**PROJECT:**  
Wayside Bridge Repairs  
Wayside Inn Road  
Sudbury, MA 01776  
Project No. 2024-WSIB-1

**ADDENDUM NO. 2 04/30/2024**

- Replace the following drawings in their entirety. (See attached)  
S-103 Wayside Inn Bridge Repair Plan & Section

DRAWING NO:  
**S-103**

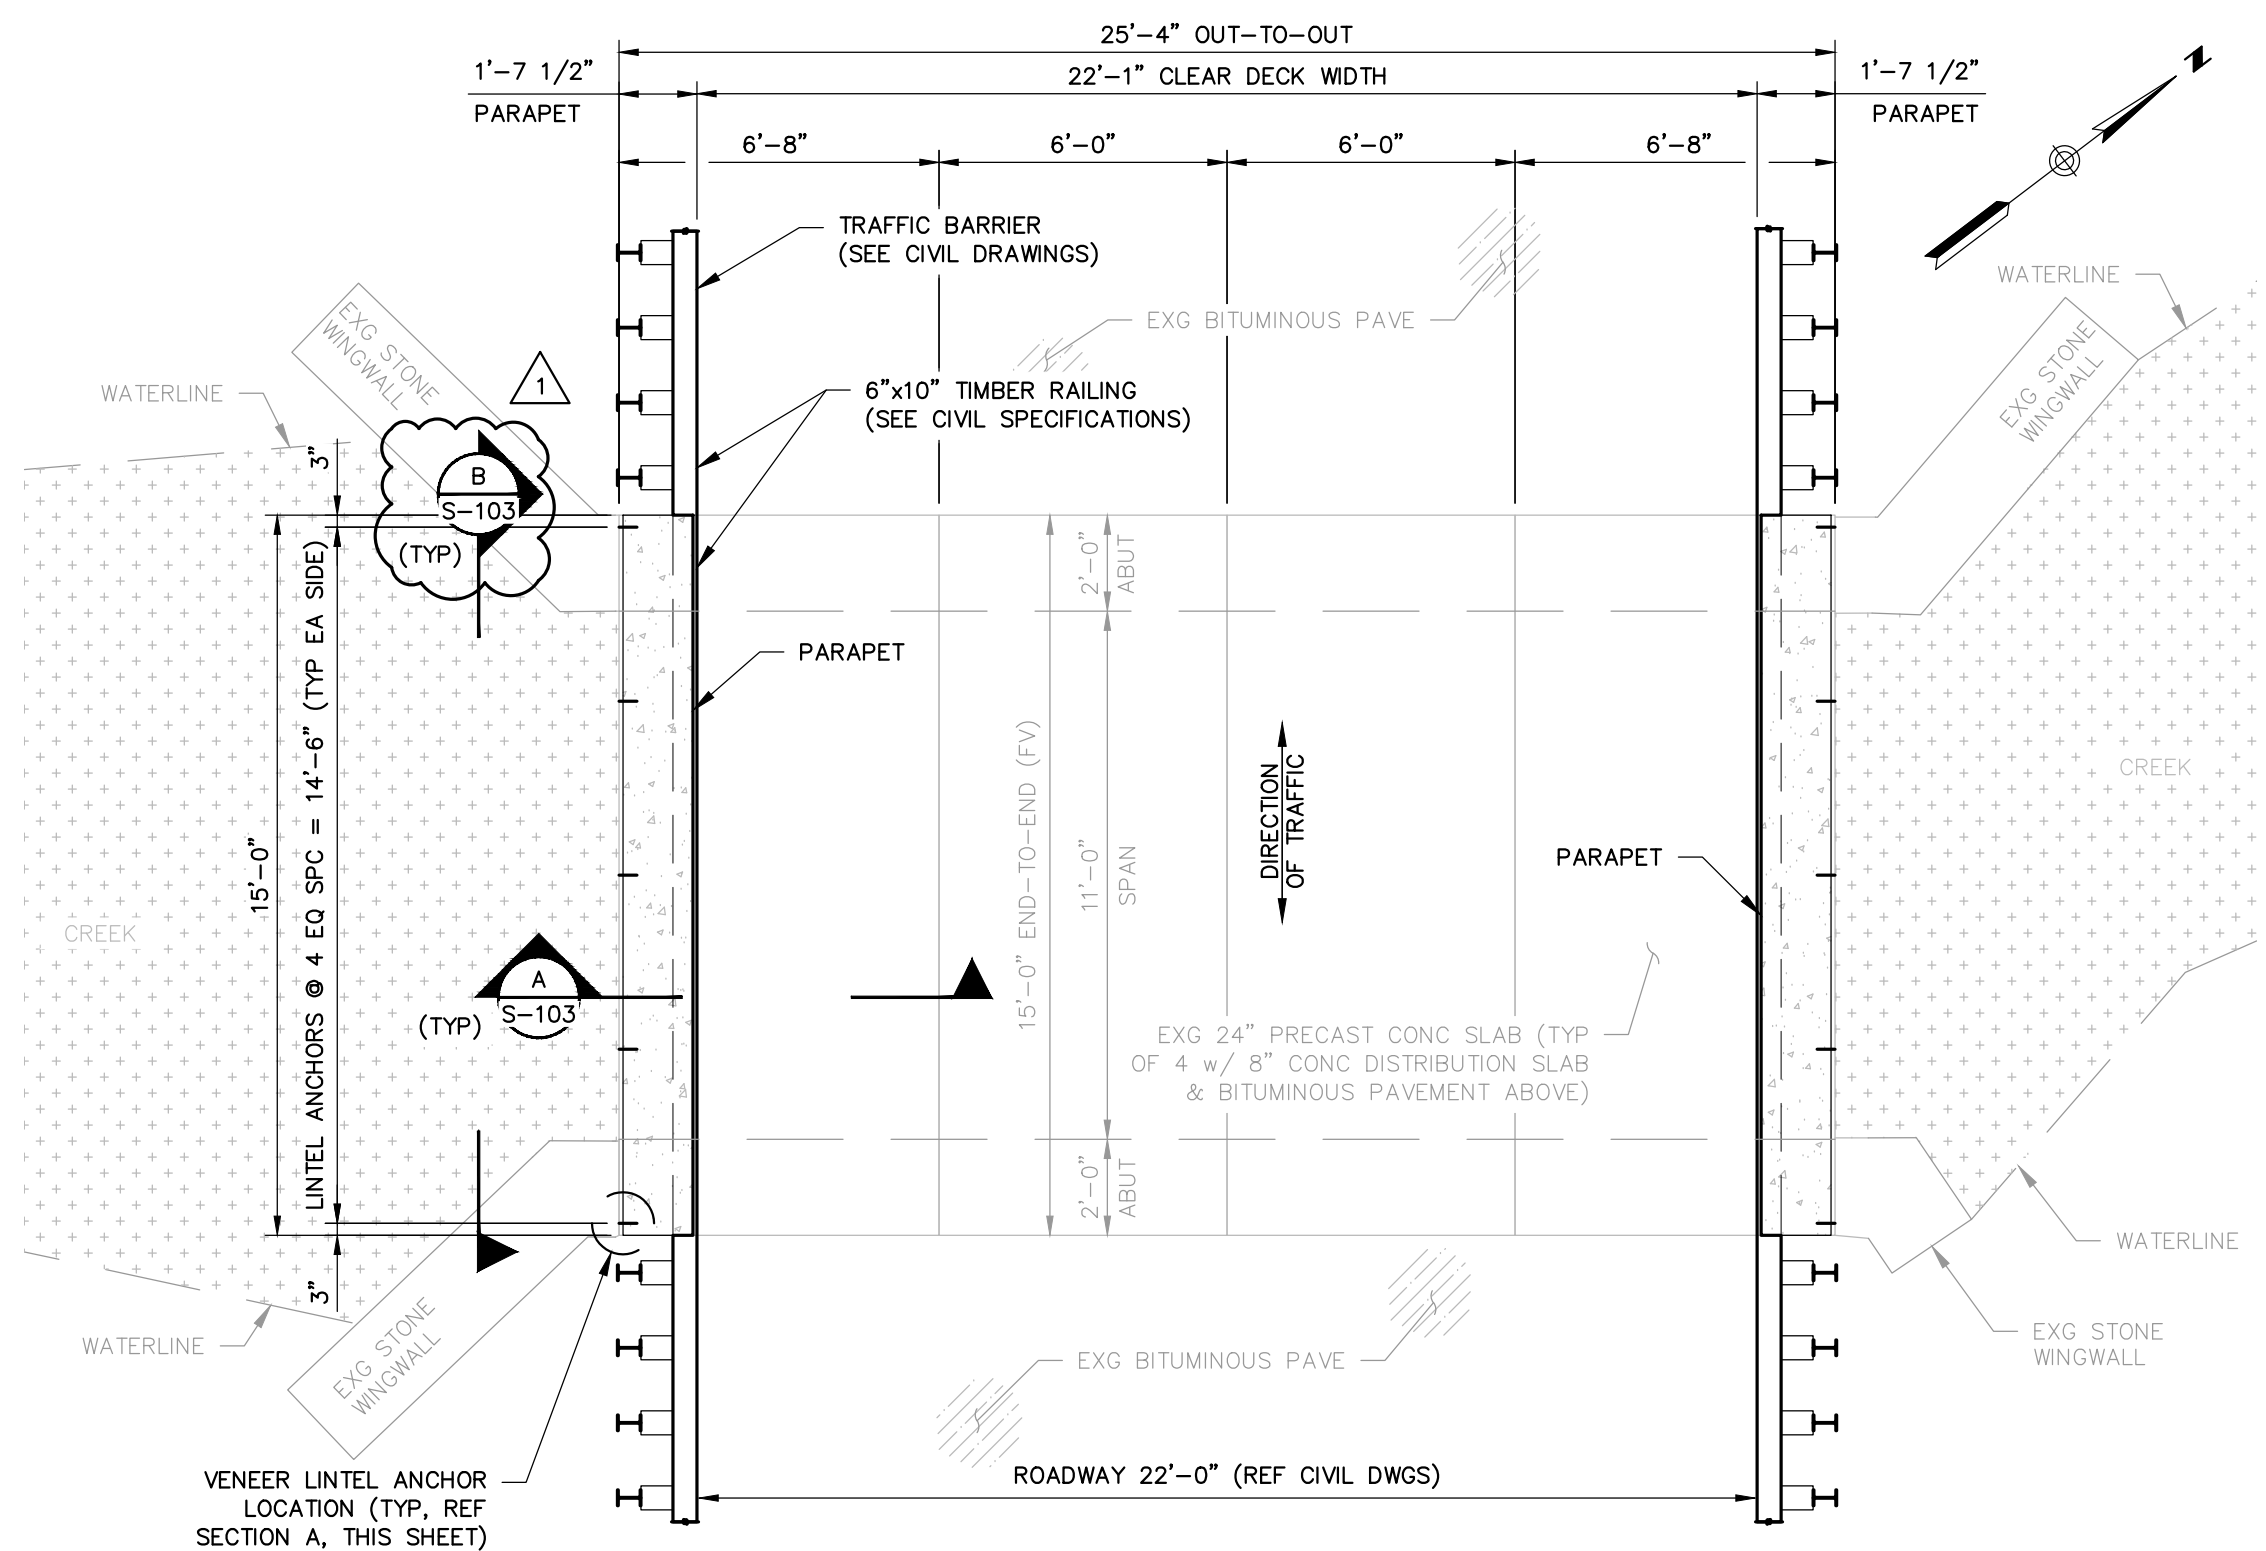
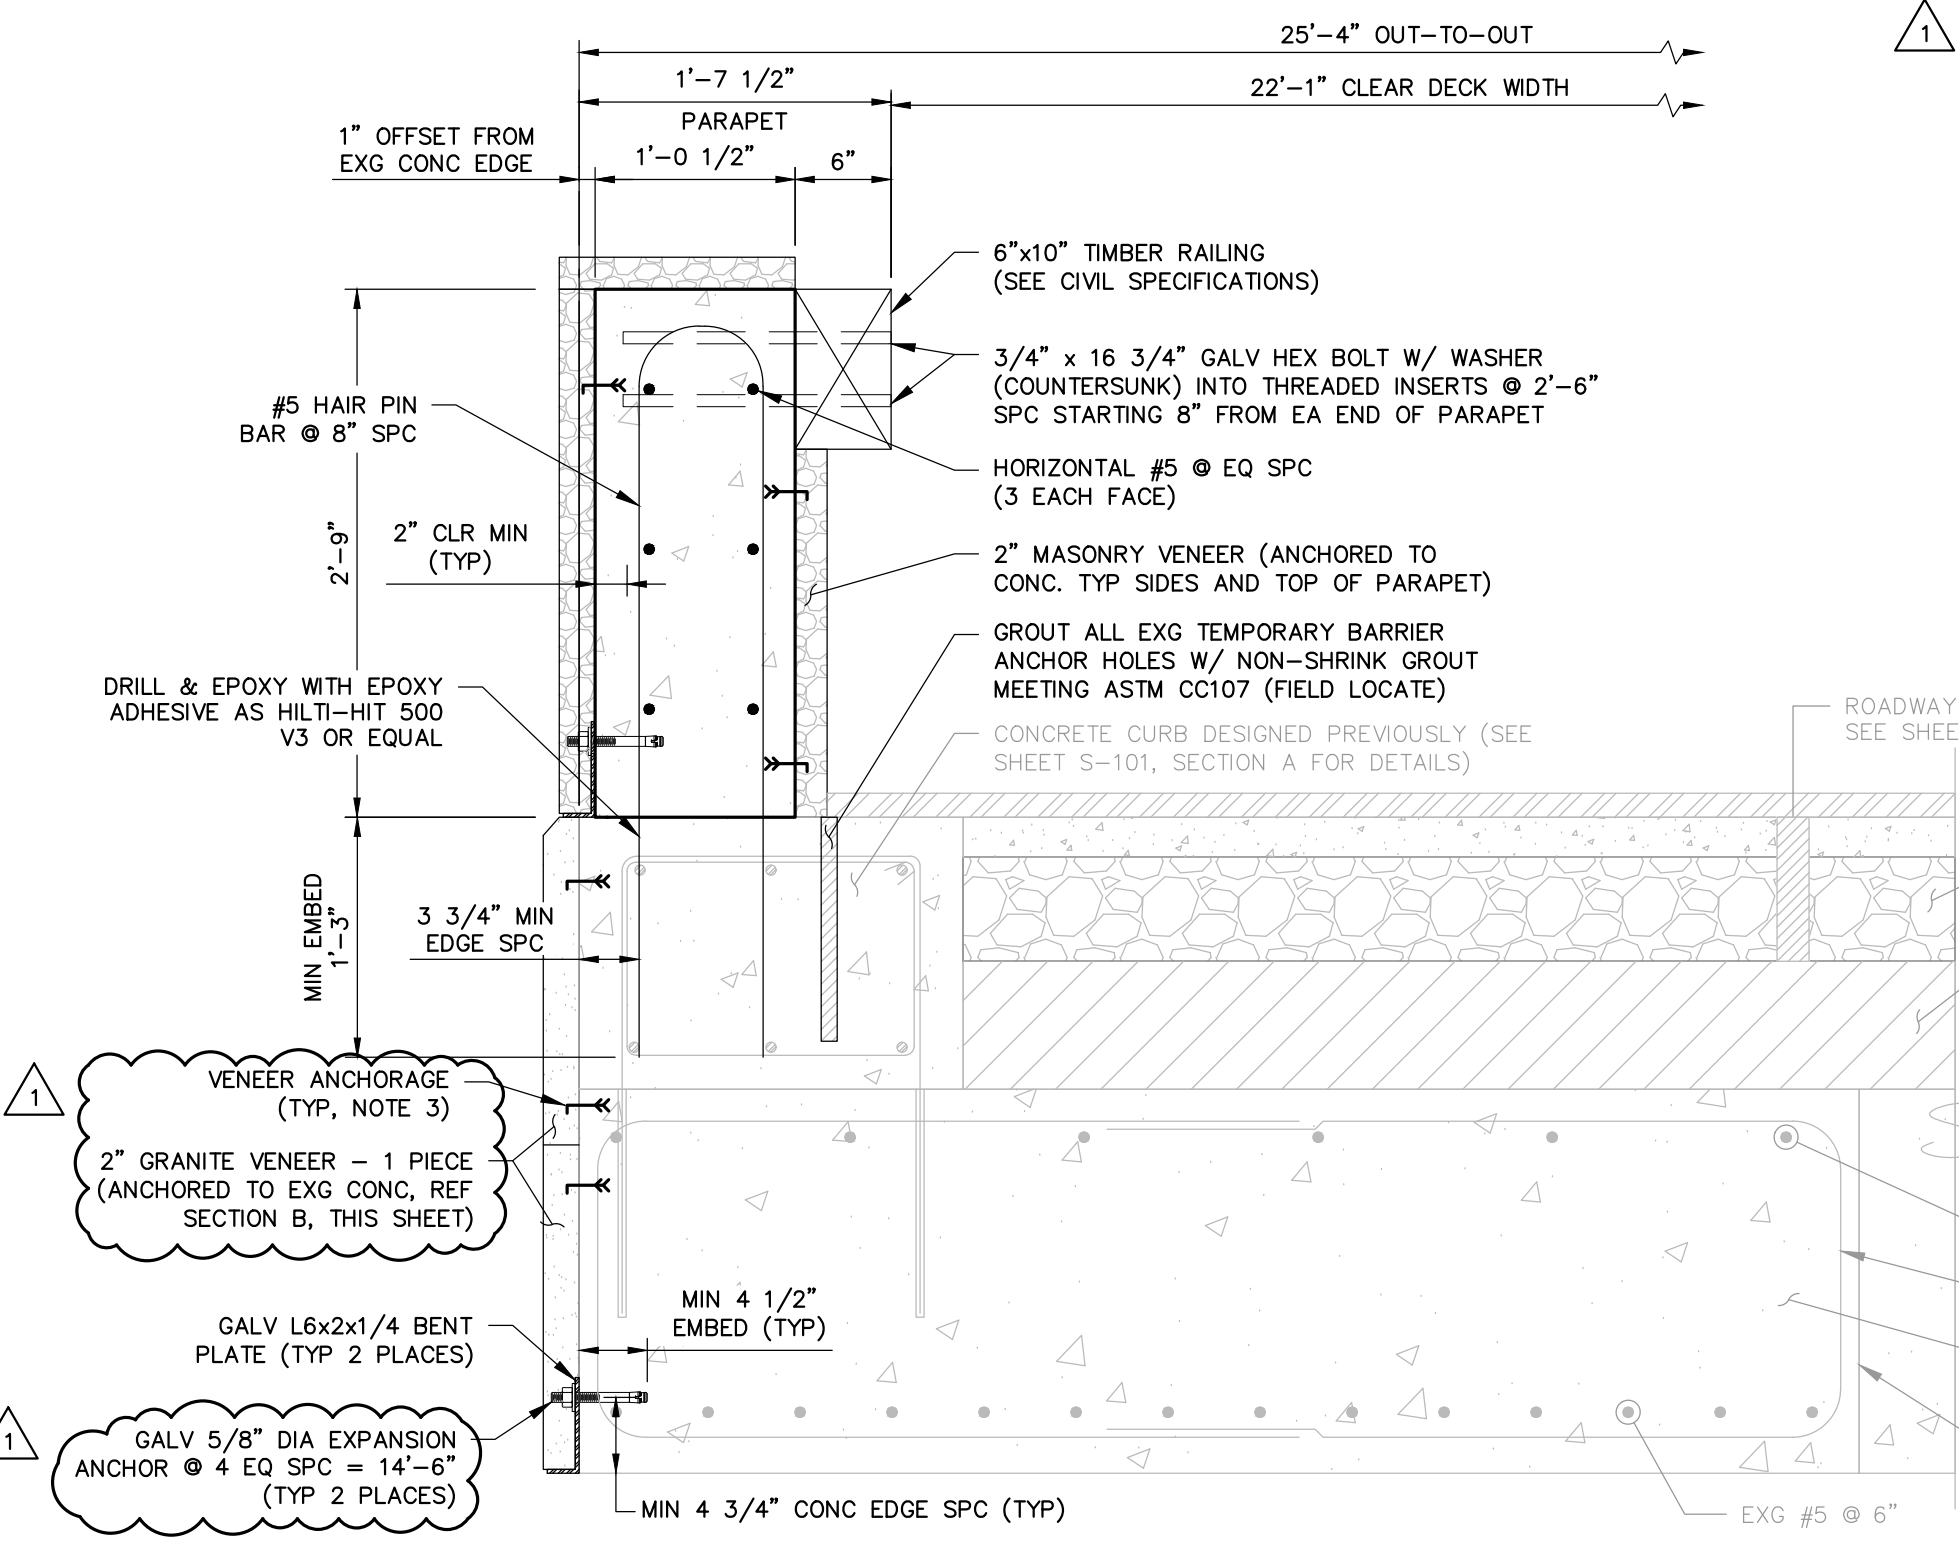
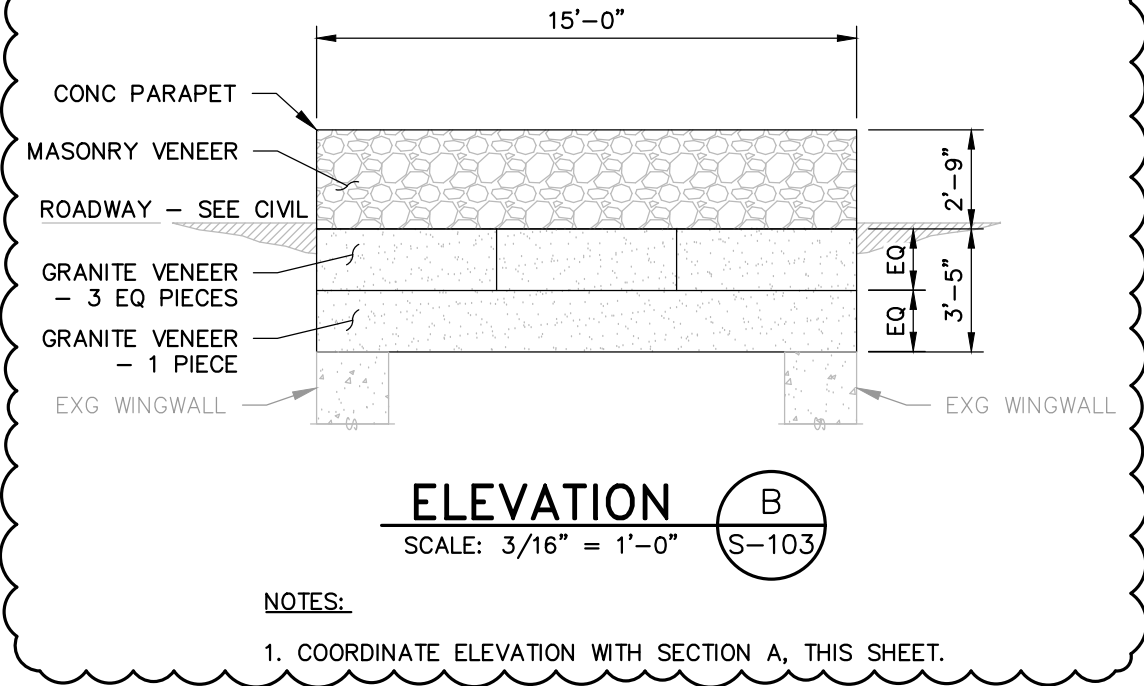
REV	MM/DD/YY	DESCRIPTION
1	04/29/24	UPDATED VENEER DESIGN AND NEW ELEVATION
0	04/10/24	ISSUE FOR BID
